STAFF RECOMMENDATION
1712 Blair Boulevard
March 17, 2021

Application: New Construction—Outbuilding
District: Belmont-Hillsboro Neighborhood Conservation Zoning Overlay
Council District: 18
Base Zoning: RM20
Map and Parcel Number: 10416004300
Applicant: Will Jenner
Project Lead: Melissa Sajid, melissa.sajid@nashville.gov

Description of Project: Application is to construct an outbuilding that is less than twenty feet (20') from the addition approved in December 2020.

A202

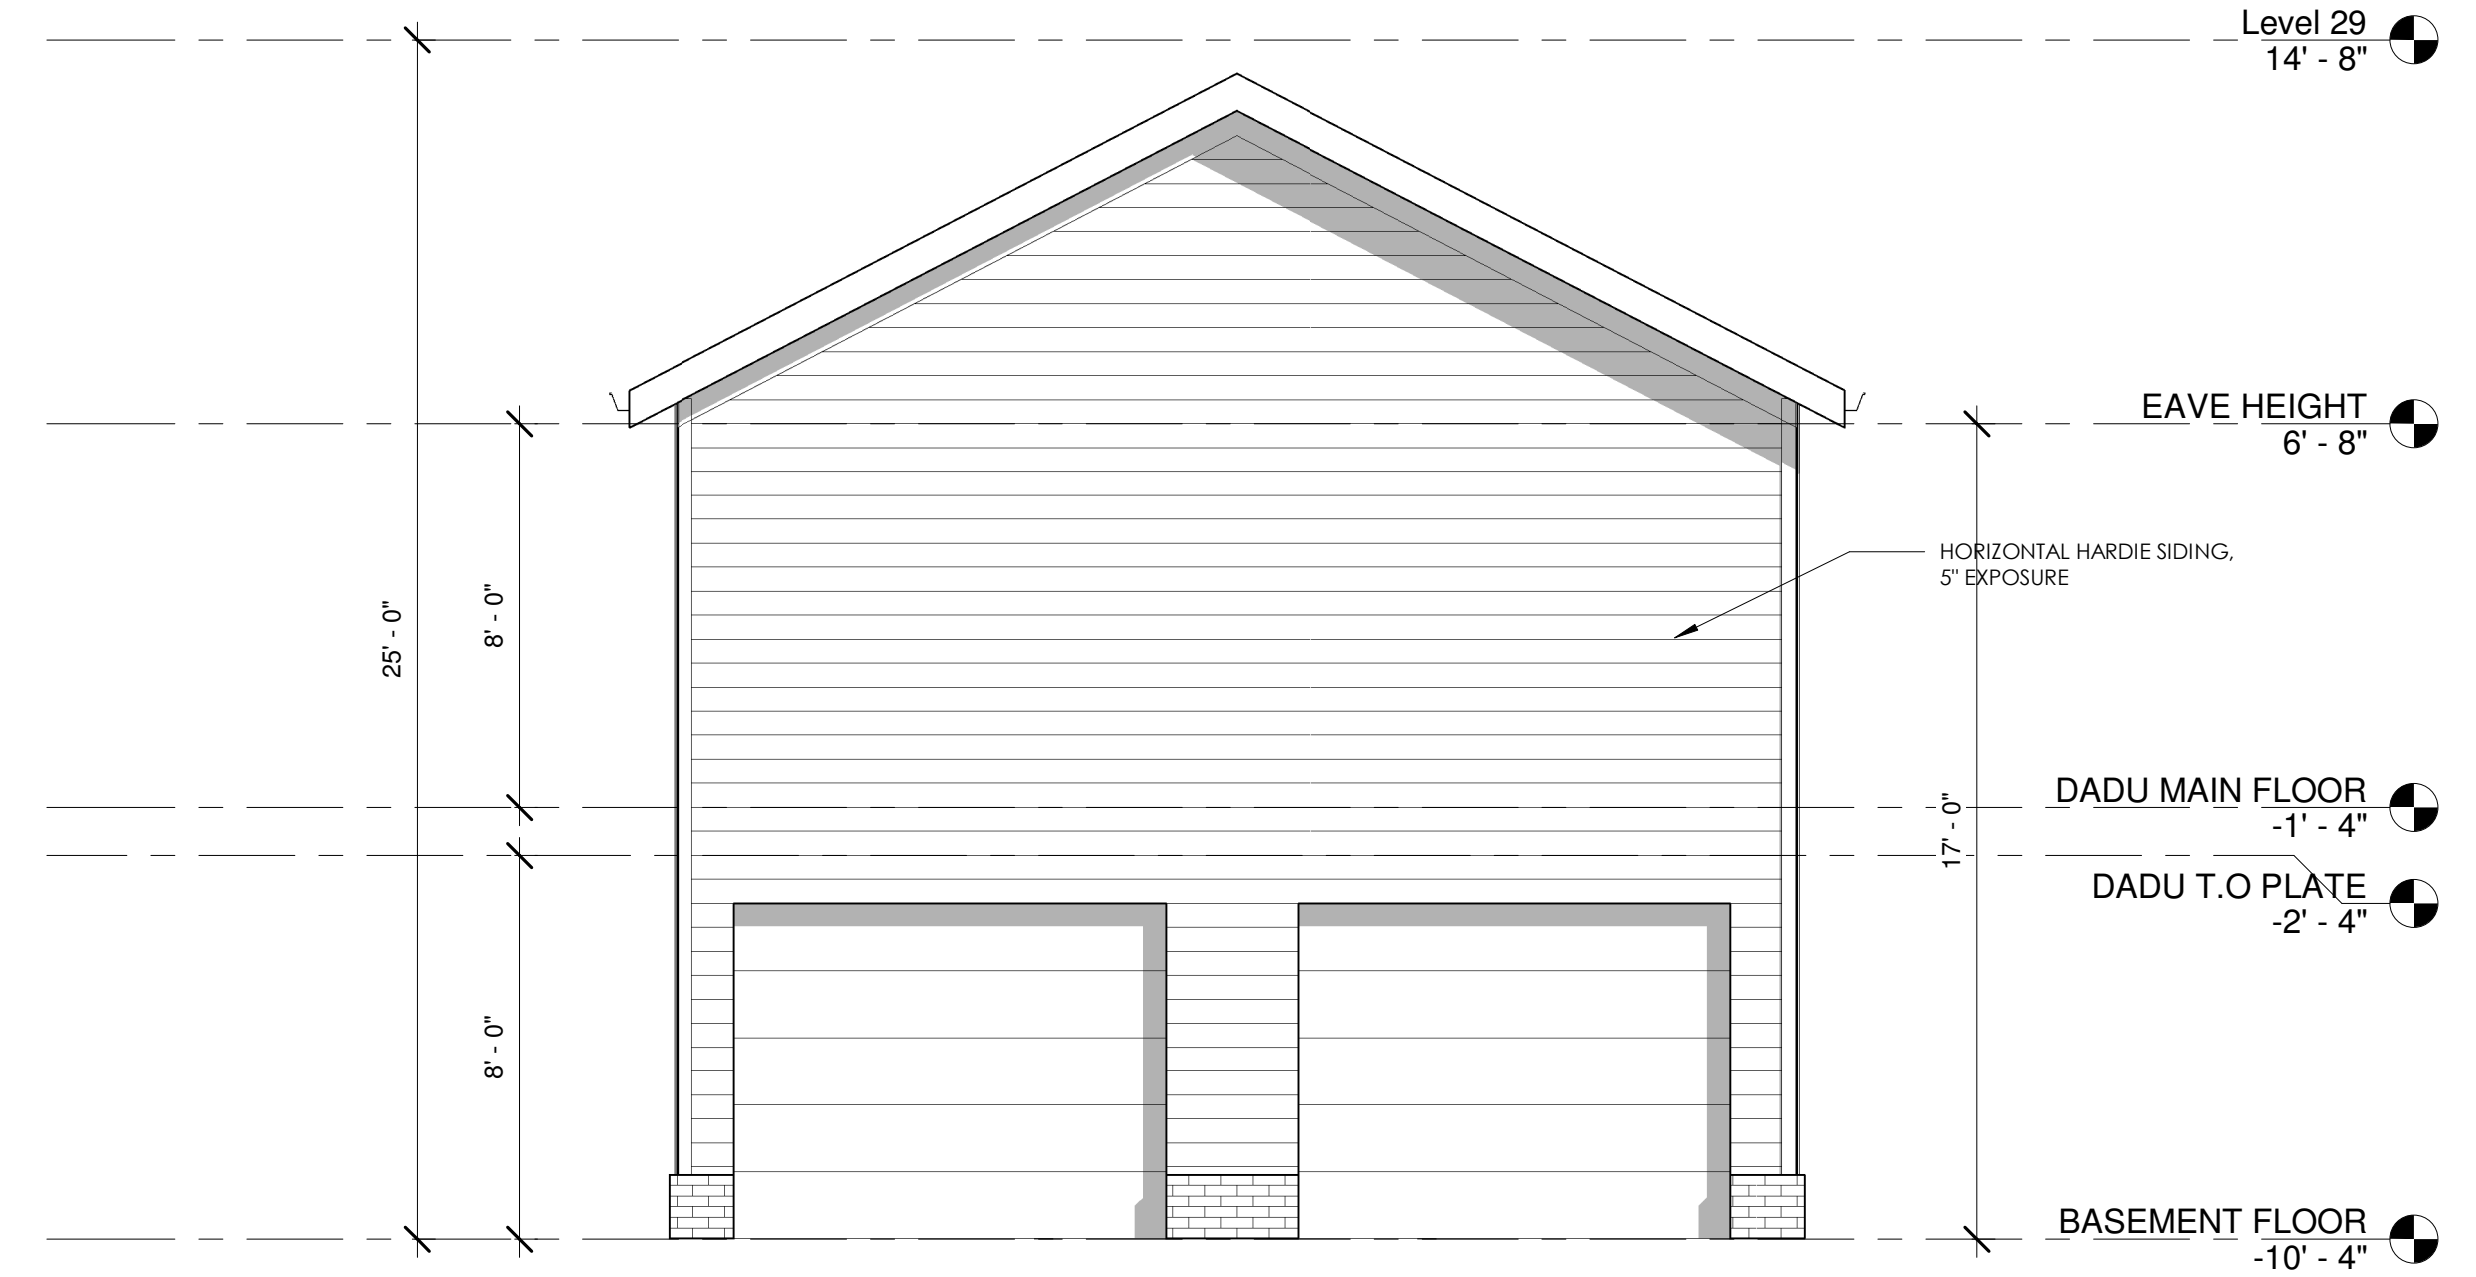
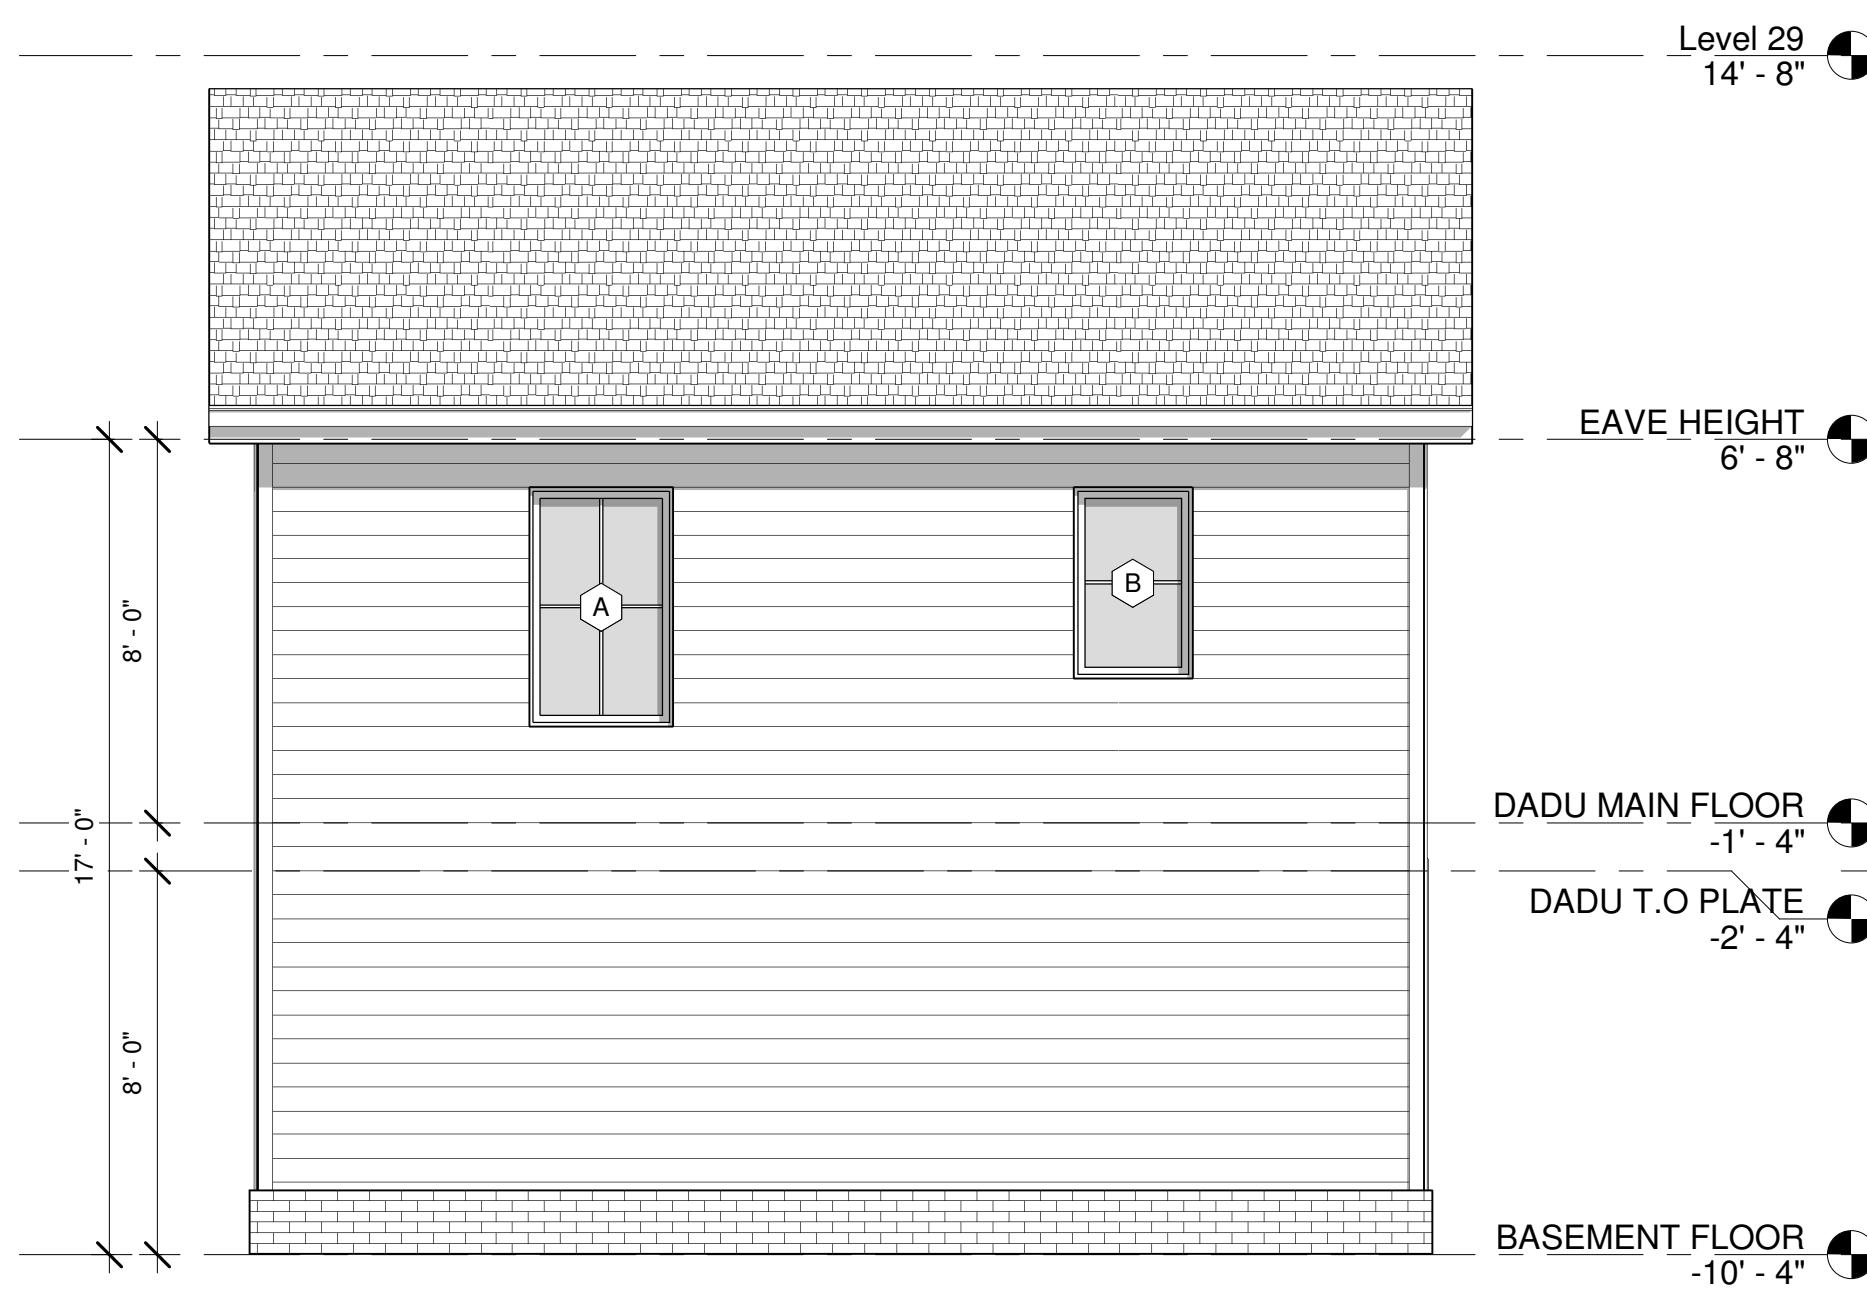
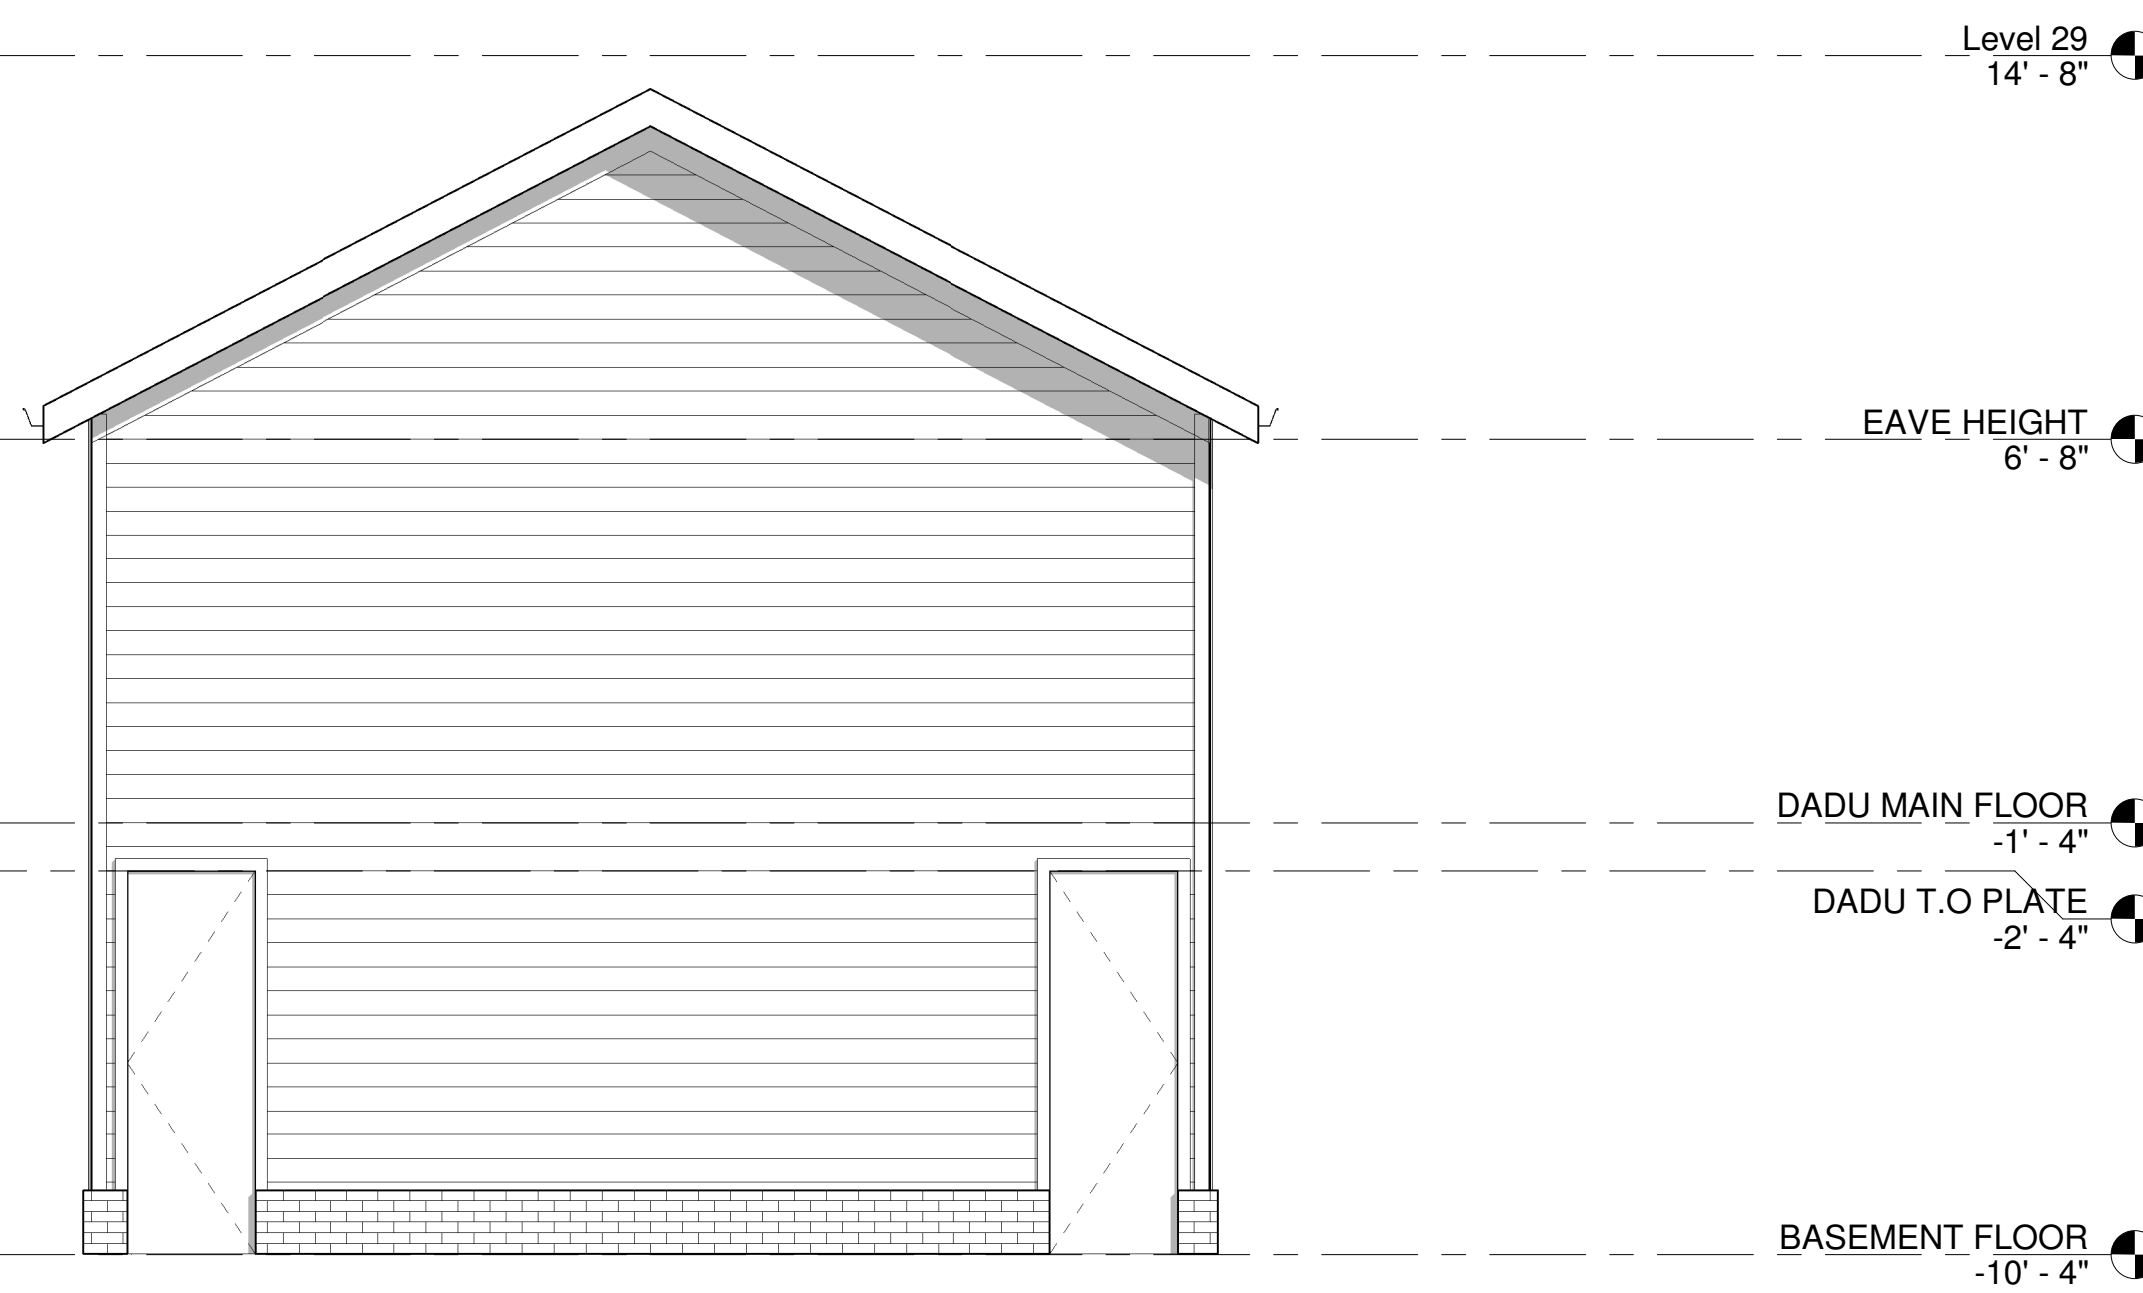
Potential maximums under Ordinance	Existing House	Proposed Outbuilding
Ridge Height	25' unless existing building is less	~ 36'	~24'4"
Eave Height	17'	~ 22'-6"	17'

Proposed Element	Proposed Outbuilding	Typical of district?
Primary form	Gable	Yes
Primary roof slope	~ 6/12	Yes

Proposed Outbuilding	Color/Texture	Needs final approval?
Foundation	Not indicated	Unknown	Yes
Primary cladding	Not indicated	Unknown	Yes
Trim	Not indicated	Unknown	Yes
Roofing	Not indicated	Unknown	Yes
Windows	Not indicated	Unknown	Yes
Doors	Not indicated	Unknown	Yes
Garage door	Not indicated	Unknown	Yes

1. Staff approve the final details, dimensions and materials of all materials prior to purchase and installation; and
2. Siding shall have a smooth finish and a maximum reveal of five inches (5").
